RESIDENT ENGINEER SERVICES FOR BURLINGTON GREENWAY REHABILITATION PHASE 3B SOUTH ~~AND OAKLEDGE FOR ALL~~ ~~UNIVERSAL ACCESS PROJECT~~

Addendum 2

PROPOSED IMPROVEMENT
BURLINGTON BIKE PATH
REHABILITATION PROJECT
PHASE 3B (SOUTH)

FILE NAME: 58I09bdr_nul.dgn	PLOT DATE: 2/19/2021
PROJECT LEADER: E.P.DETRICK	DRAWN BY: C.K.FORD
DESIGNED BY: C.K.FORD	CHECKED BY: E.P.DETRICK
PLAN AND PROFILE (SHEET 1 OF 5)	SHEET 12 OF 48

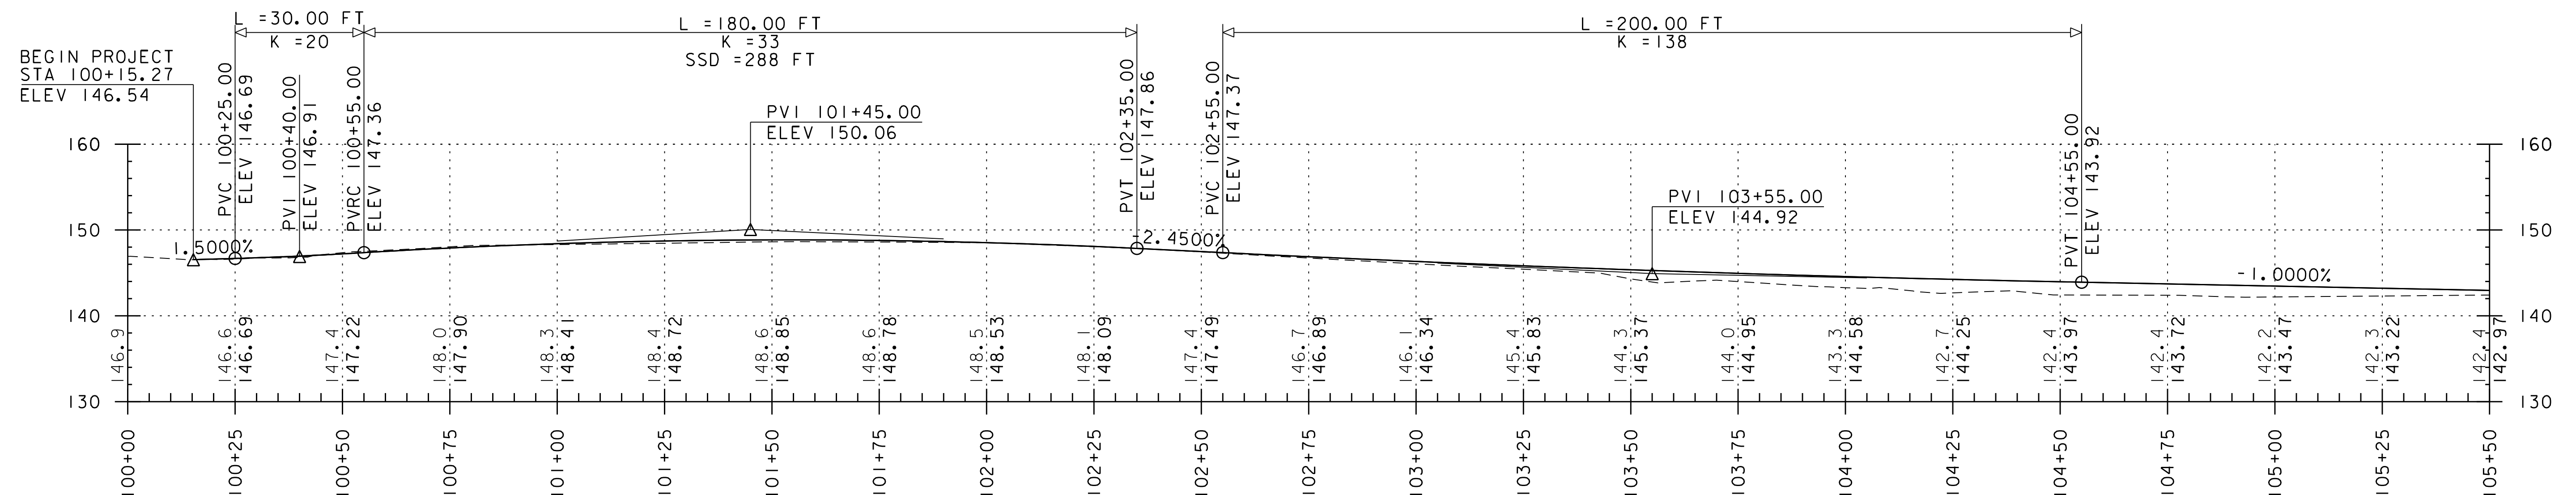
3) Please confirm that consultants should assemble their RE proposals assuming that the entire Greenway reconstruction project will take place in 2021.

The Greenway reconstruction project will be divided and the RE proposals should account for both Sections.

Section 1 of the Greenway reconstruction project for 2021 will consist of the Flynn Avenue intersection/ Oval/ Beach Access and the Gateway at Austin Drive. From approximately STA 121+96.11 to STA. 127+00.00 on the north end (See Sheets 15 +16) and STA 100+15.27 and STA.100+15.27 (See Sheet 12).
